## Firmware Release and new NOR for 16GB NVDIMM-N

**PCN: 32536**

**Published: 2018-01-11**

**Type:** Firmware Revision

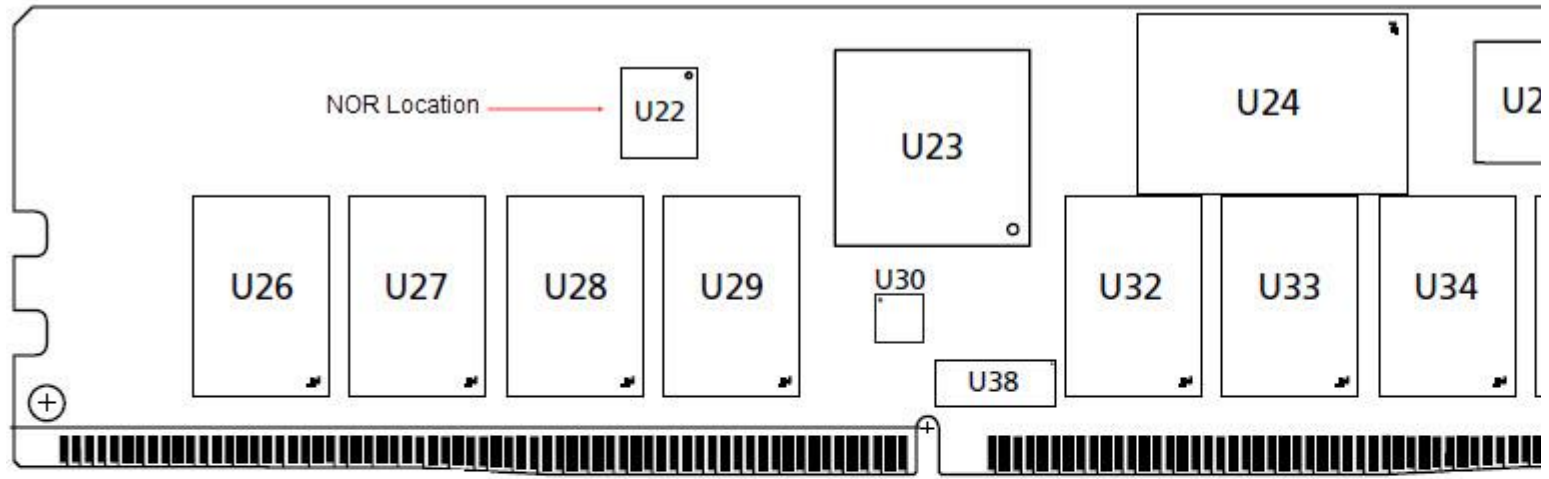
**Method of Identification:** NVDIMM-N part numbers below will have FW version 2.4 and NOR part number MT25QL128ABA1EW7-0M03IT with top mark RWM03.

The FW version can be identified on the label as shown in example picture.

The NOR is located on the backside of the module as indicated in the drawing below.

NOR device on NVDIMM is being replaced with equivalent. The current NOR device, N25Q064A13EF640FN04 is EOL as described in PCN 32435. It is being replaced with MT25QL128ABA1EW7-0M03IT.
